NRC-02-064

July 26, 2002

Docket 50-305
Operating License DPR-43
Kewaunee Nuclear Power Plant
License Amendment Request 185 To The Kewaunee Nuclear Power Plant Technical Specifications, "Core Operating Limits Report Implementation."

CORE OPERATING LIMITS REPORT CYCLE 25

Figure 1
Safety Limits-Reactor Core

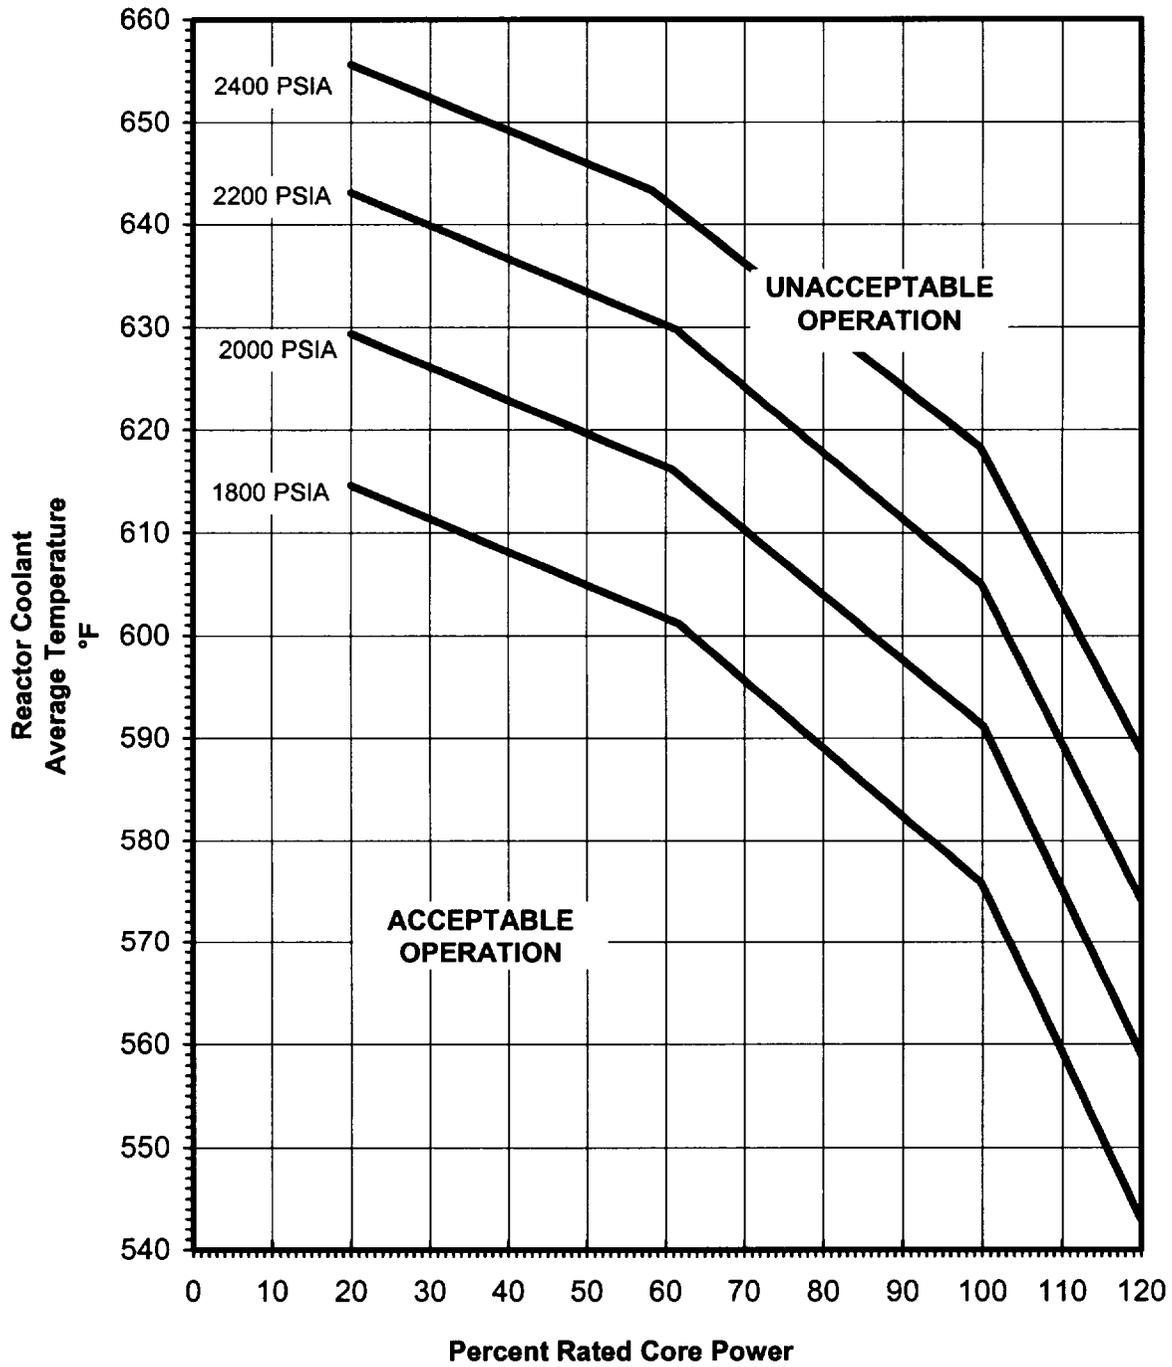
- a. The combination of rated power level, coolant pressure, and coolant temperature shall not exceed the limits ~~shown in Figure TS 2.1-1~~ specified in the COLR. The safety limit is exceeded if the point defined by the combination of Reactor Coolant System average temperature and power level is at any time above the appropriate pressure line.
- b. The departure from nucleate boiling ratio (DNBR) shall be maintained ≥ 1.14 for the HTP DNB correlation
- c. The peak fuel centerline temperature shall be maintained < 4700 °F

The ~~curves of Figure TS 2.1-1~~ SAFETY LIMIT curves as provided in the Core Operating Report Limits Report which show the allowable power level decreasing with increasing temperature at selected pressures for constant flow (two loop operation) represent the loci of points of thermal power, coolant system average temperature, and coolant system pressure for which either the DNBR is equal to the DNBR limit or the average enthalpy at the exit of the core is equal to the saturation value. At low pressures or high temperatures the average enthalpy at the exit of the core reaches saturation before the DNBR ratio reaches the DNBR limit and thus, this limit is conservative with respect to maintaining clad integrity. The area where clad integrity is assured is below these lines.

The combination of rated power level, coolant pressure, and coolant temperature shall not exceed the limits shown in COLR Figure 1. The safety limit is exceeded if the point defined by the combination of Reactor Coolant System average temperature and power level is at any time above the appropriate pressure line

Figure 2
Required Shutdown Reactivity vs Boron Concentration

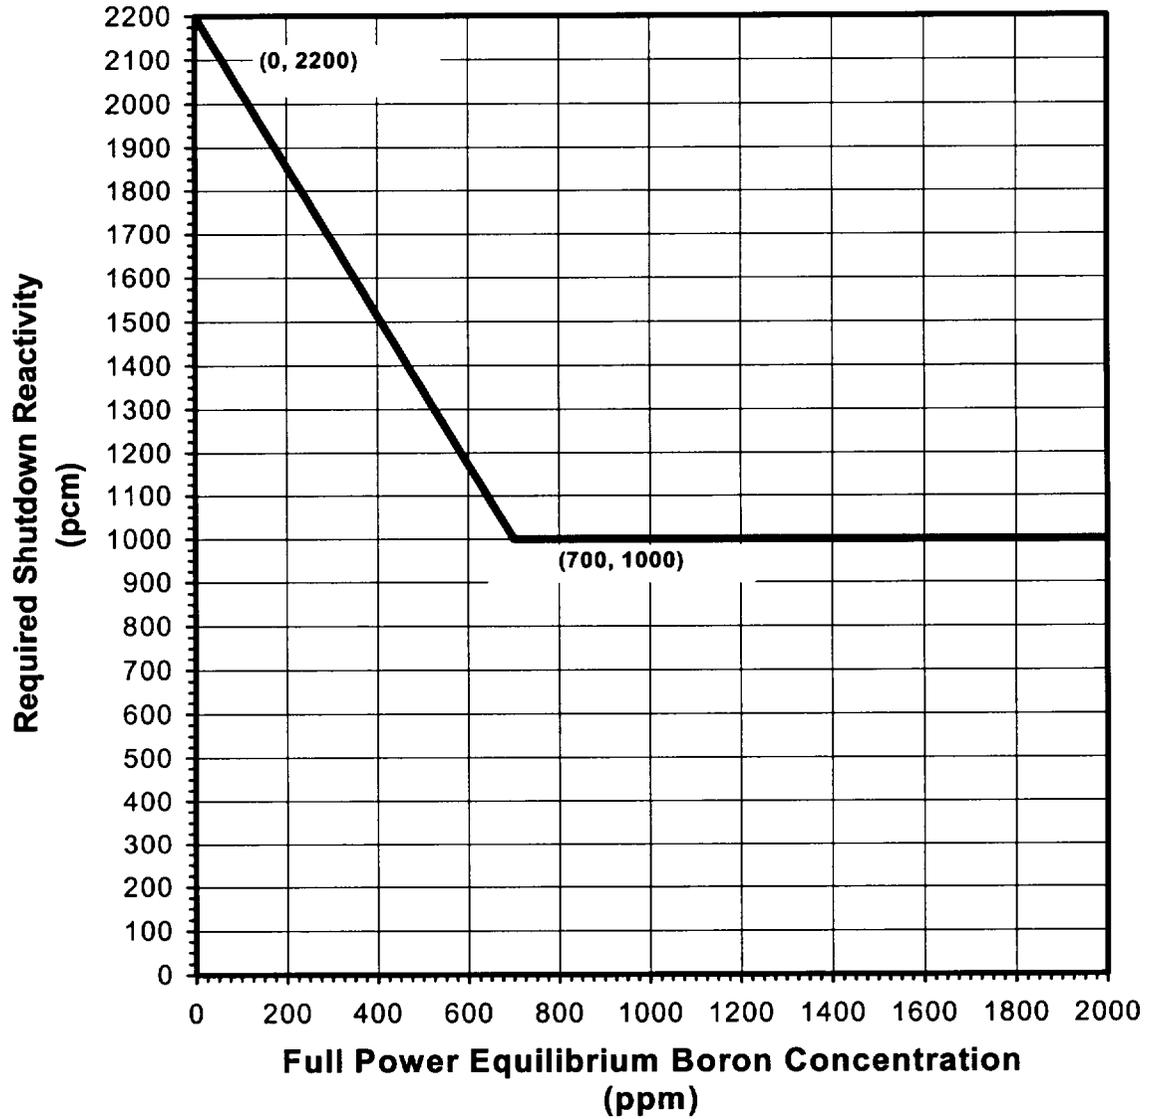
When the reactor is subcritical prior to reactor startup, the ~~HOT SHUTDOWN MARGIN~~ margin shall be at least that ~~shown in Figure TS 3.10-1~~ as specified in the COLR. ~~Shutdown margin as used here is defined as the amount by which the reactor core would be subcritical at HOT SHUTDOWN conditions if all control rods were tripped, assuming that the highest worth control rod remained fully withdrawn, and assuming no changes in xenon or boron.~~

- Achieve HOT SHUTDOWN within the following 6 hours
 3. Insertion limit does not apply during physics tests or during periodic exercise of individual rods. However, the shutdown margin, ~~indicated in Figure TS 3.10-1 as~~ specified in the COLR, must be maintained except for the Low Power Physics Test to measure control rod worth and shutdown margin. For this test, the reactor may be critical with all but one high worth rod inserted.

2.2.1 When the reactor is subcritical prior to reactor startup, the SHUTDOWN margin shall be at least that shown in COLR Figure 2.

Figure 3
Hot Channel Factor Normalized Operating Envelope

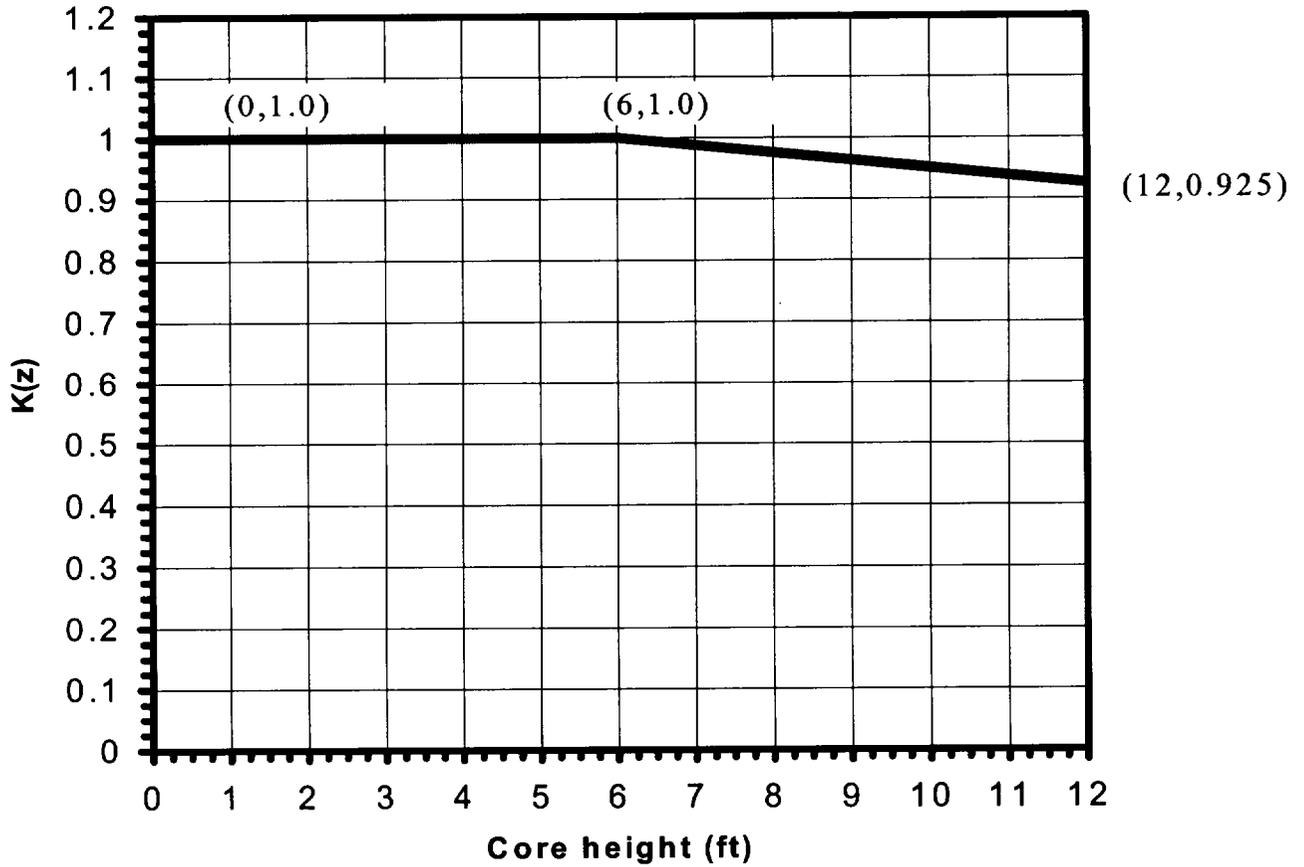
_____ K(Z) _____ is the function given in Figure TS 3.10.2

K(Z) is the function given in Figure 3

Figure 4
Control Bank Insertion Limits

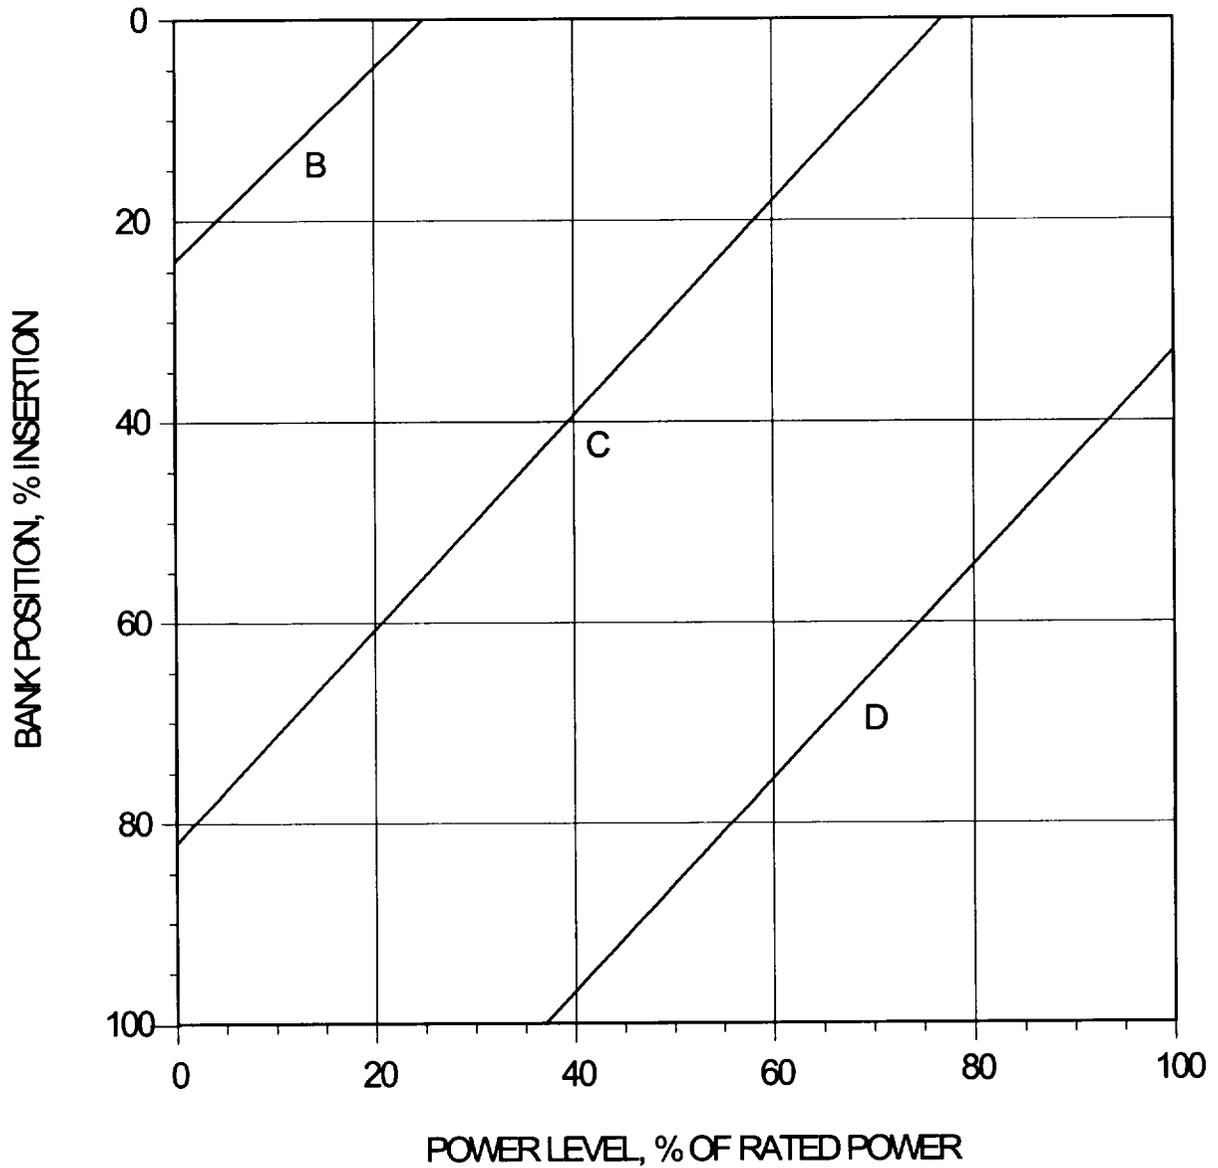
2. The control banks shall be limited in physical insertion; insertion limits are ~~shown in~~ specified in the COLR ~~Figure TS 3.10-3~~. If any one of the control bank insertion limits ~~shown in Figure TS 3.10-3~~ is not met:

- A. Within ~~4 one~~ one hour, initiate boration to restore control bank insertion to within the limits of ~~Figure TS 3.10-3~~ specified in the COLR, and

- B. Restore control bank insertion to within the limits of ~~Figure TS 3.10-3~~ specified in the COLR within ~~2 two~~ two hours of exceeding the insertion limits.

2. Control rod banks are sequenced with overlapping banks ~~as shown in Figure TS 3.10-3~~as specified in the COLR.
3. The control bank insertion limits as specified in the COLR are not violated, except as allowed by TS 3.10.d.2.

2.5.1 The control banks shall be limited in physical insertion; insertion limits are shown in COLR Figure 4
